Introduction of Alternative Energy Chain Supply

An alternative energy chain (caterpillar/cat-track) will shortly be introduced on products being supplied from Steelbro China

Currently only standard SB450s (rigid & trombone chassis) which are fully manufactured or supplied in kit form from Steelbro China will be affected. This change was introduced on serial number SB9064. Products manufactured in New Zealand will continue to use the original (Igus brand) energy chain.

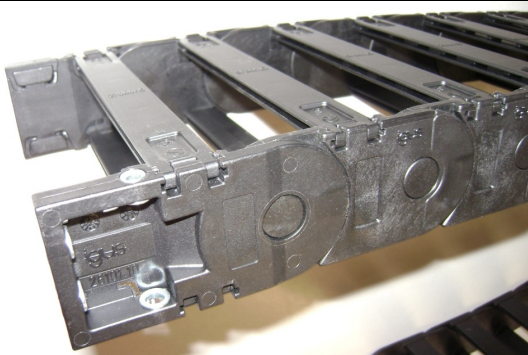
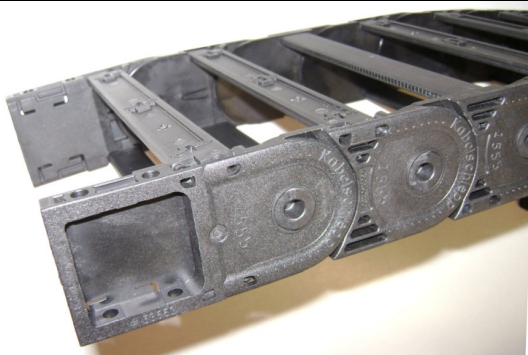
The individual segments of each energy chain are not interchangeable with each other (ie Igus energy chain segments cannot be connected to Kabel-Schlepp segments and vice versa). However a complete Kabel-Schlepp chain may replace an Igus chain and vice versa.

The Kabel-Schlepp end pieces are mounted using 4 bolts, whereas the Igus ones only used 2 bolts. If the Kabel-Schlepp chain is sent as a spare part to replace Igus, then extra mounting holes will need to be drilled (and, if required, tapped).

Supply Plant	New Zealand	China
Item	Igus brand	Kabel-Schlepp brand
Main chain section	S1-22715	CR-42171
End sections (pair)	S1-22716	CR-42172
